**As-Built Baseline Monitoring Report**

**RES Randleman Group A  
Riparian Buffer Mitigation Project**

**DMS Project # 100046 (Contract # 7427)**

RE: RES Randleman Group A: As-Built Baseline Monitoring Report (NCDMS ID 100046)

**Figure 3a**  
**As-Built Map**  
**RES Randleman Group A**  
**Pequod Site**  
**Randolph County, NC**

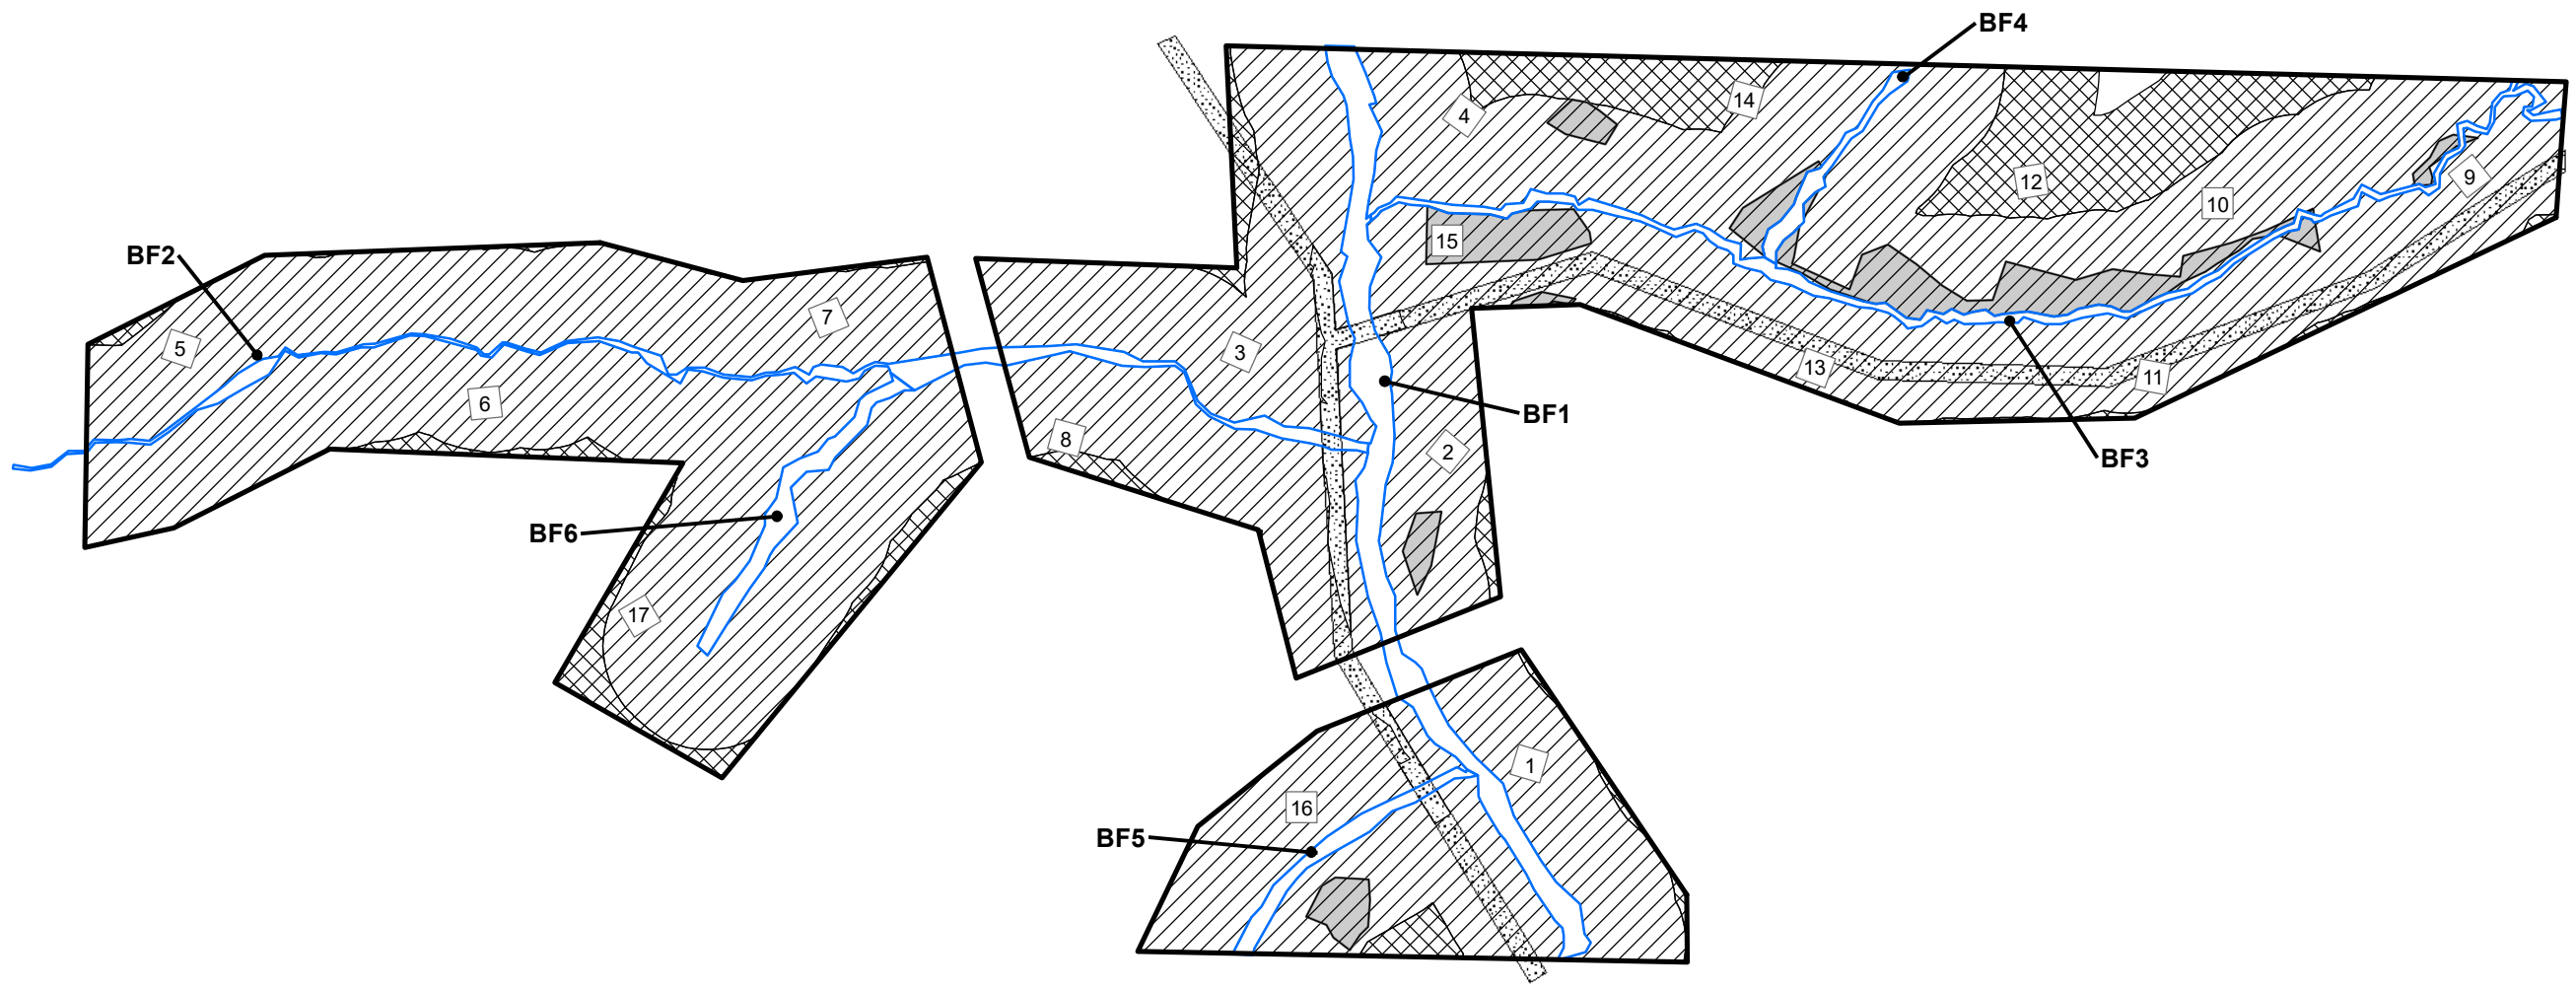
**Figure 3a** – Please correct spelling error in map legend (Sewer Easement spelled incorrectly).  
[Done.](#)

**Figure 3c**  
**As-Built Map**  
**RES Randleman Group A Sunbeam Site**  
**Randolph County, NC**

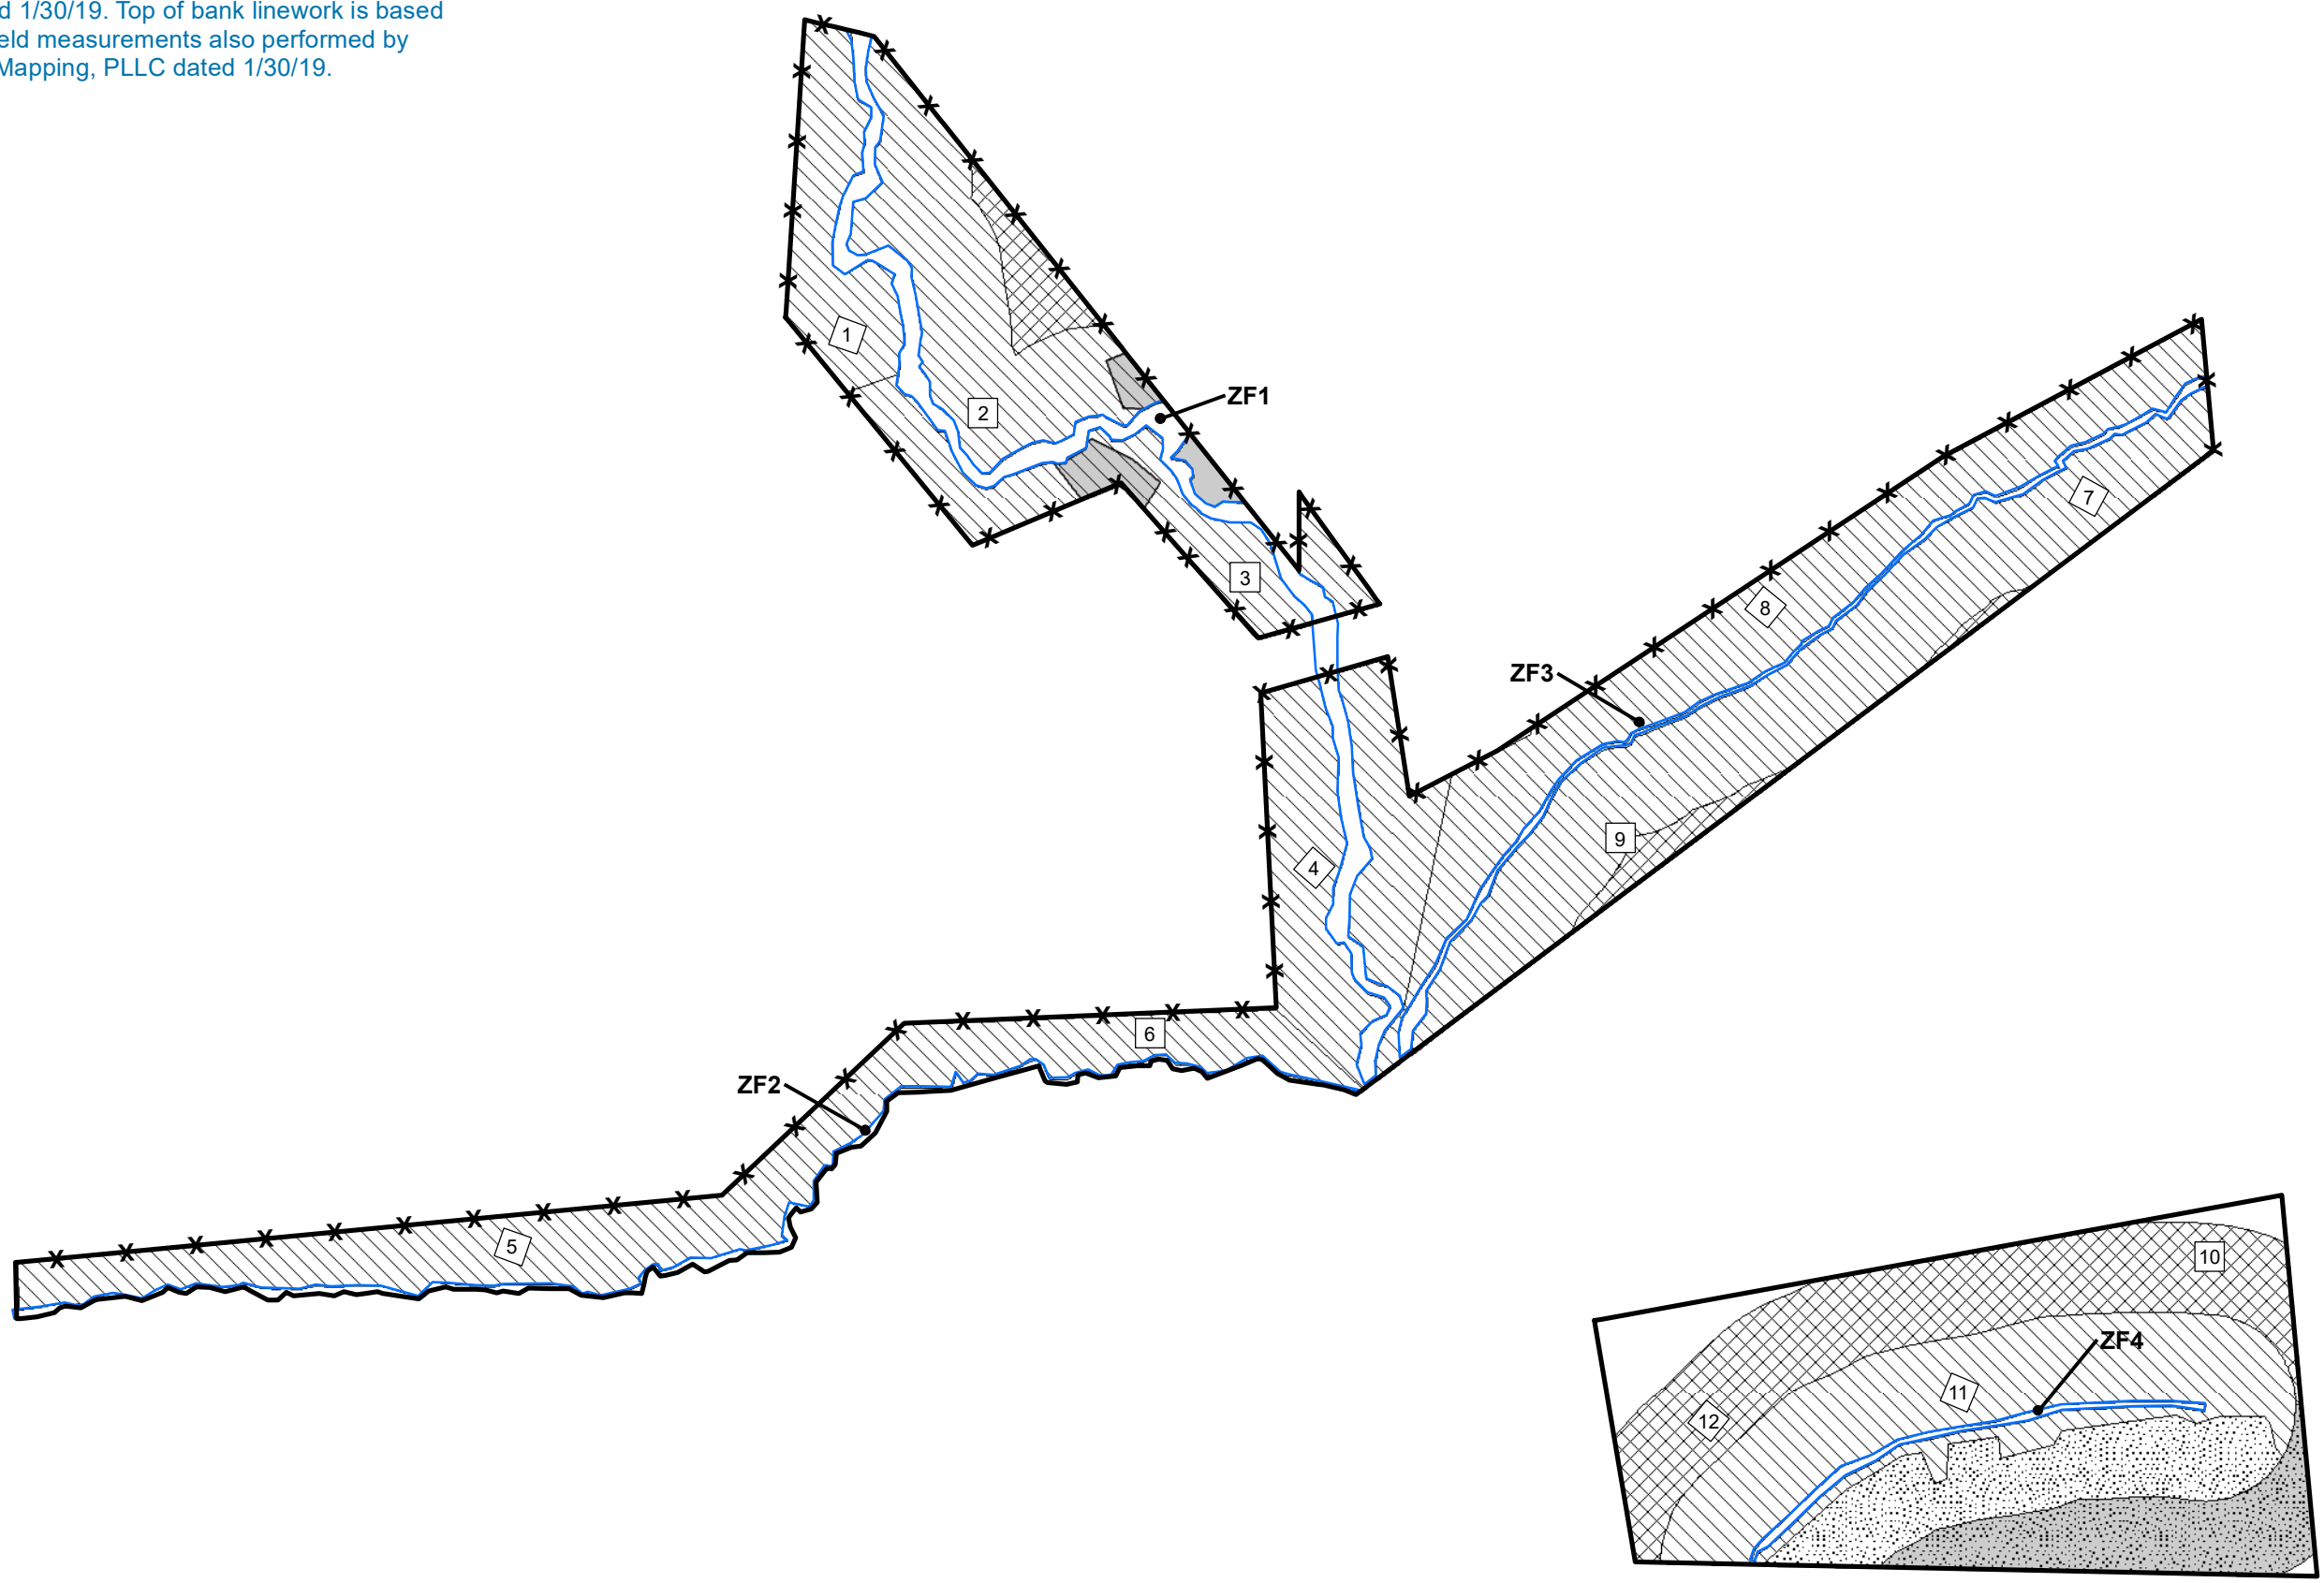
**CCPVs** – Please add fencing to all CCPVs and As-built maps where it was installed.  
[New fencing was only installed at Sunbeam. The CCPV and As-built map have been updated.](#)
